Corridor 220-221

North Rock Springs Corridor

Corridor Purpose and Rationale

Figure 3. Map of Conflict Areas in Vicinity of Corridor 220-221

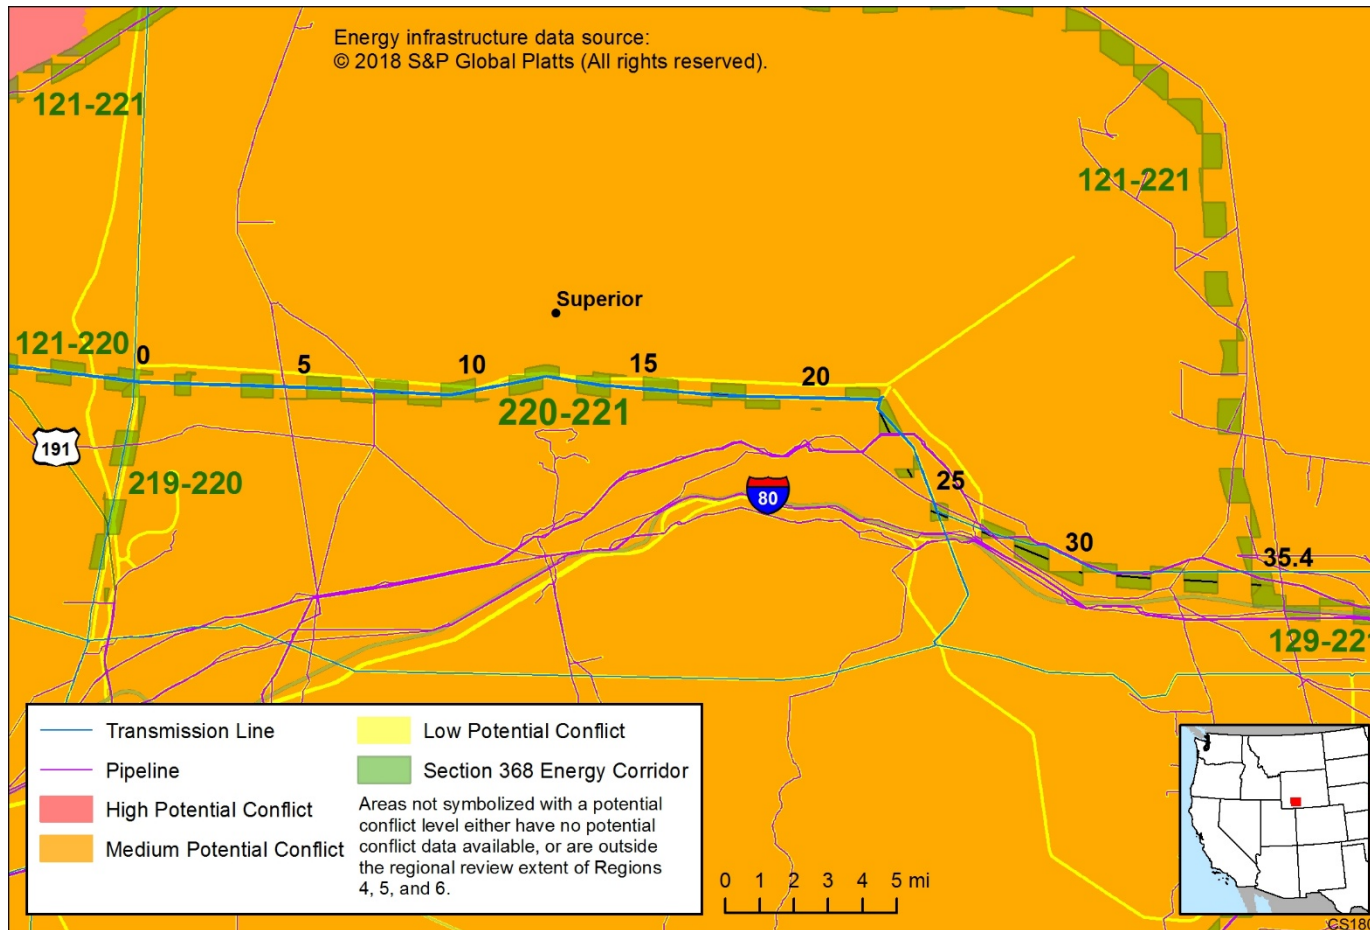
Figure 3 reflects a comprehensive resource conflict assessment developed to enable the Agencies and stakeholders to visualize a corridor’s proximity to environmentally sensitive areas and to evaluate options for routes with lower potential conflict. The potential conflict assessment (low, medium, high) shown in the figure is based on [criteria](#) found on the WVEC Information Center at www.corridoreis.anl.gov. To meet the intent of the Energy Policy Act and the Settlement Agreement siting principles, corridors may be located in areas where there is potentially high resource conflict; however, where feasible, opportunity for corridor revisions should be identified in areas with potentially lower conflict.

Figure 4. Corridor 220-221, Corridor Density Map

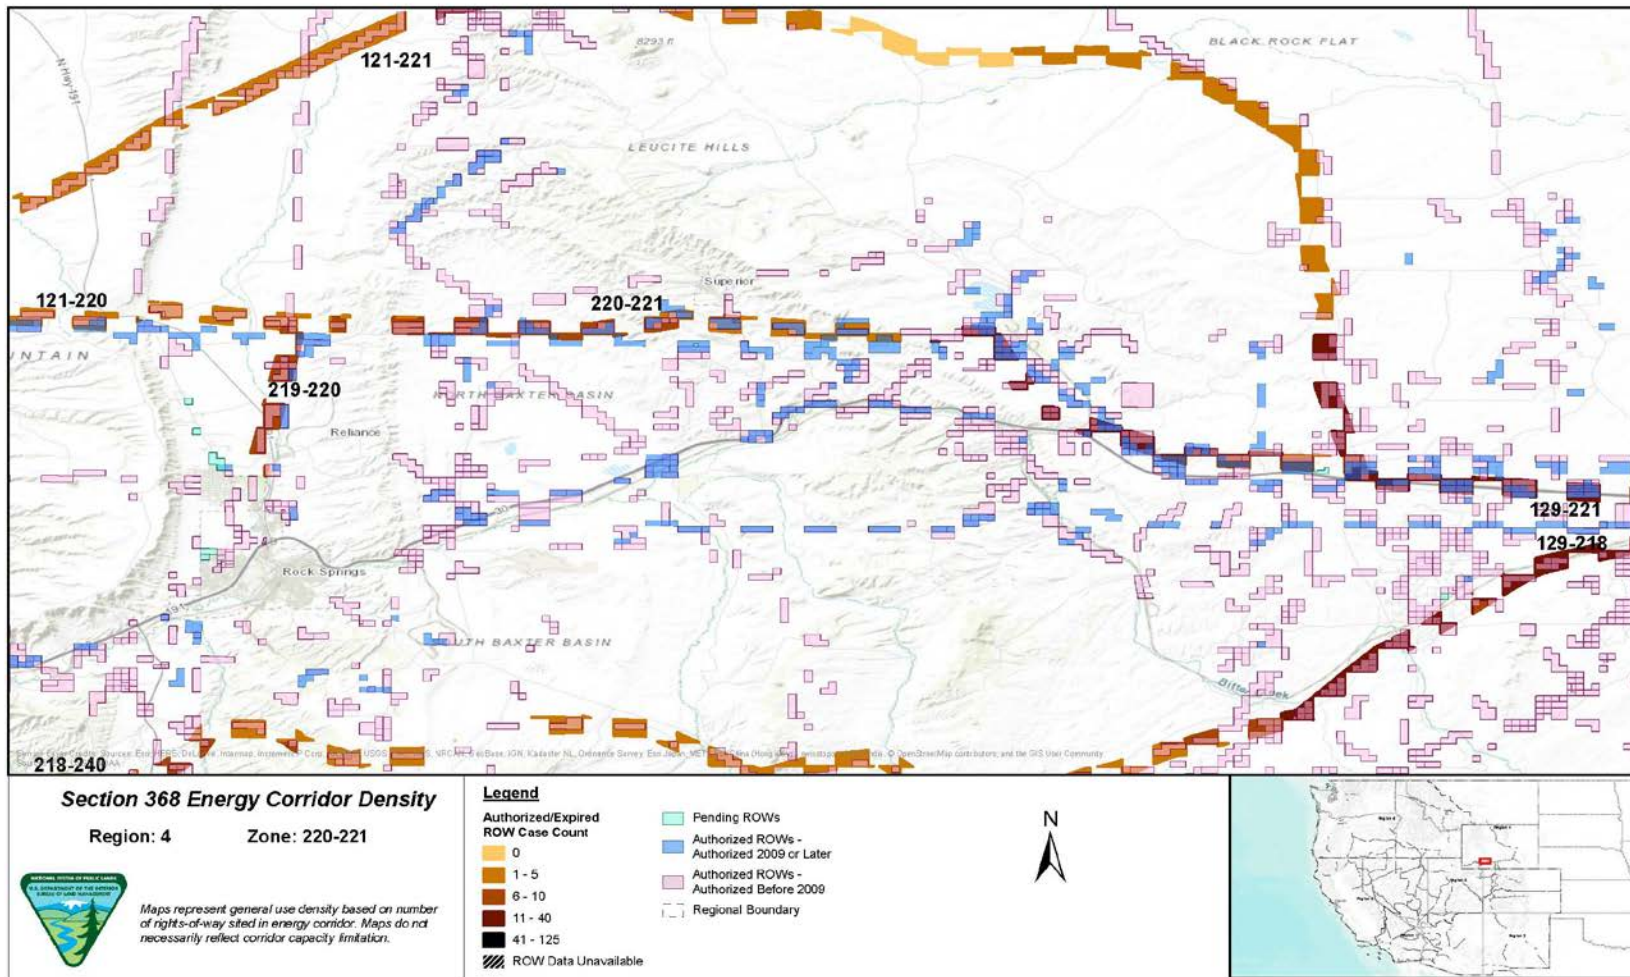
Figure 4 shows the density of energy use to assist in evaluating corridor utility. ROWs granted prior to the corridor designation (2009) are shown in pink; ROWs granted after corridor designation are shown in blue; and pending ROWs under current review for approval are shown in turquoise. Note the ROW density shown for the corridor is only a snapshot that does not fully illustrate remaining corridor capacity. Not all ROWs have GIS data at the time this abstract was developed. BLM and USFS are currently improving their ROW GIS databases and anticipate more complete data in the near future.
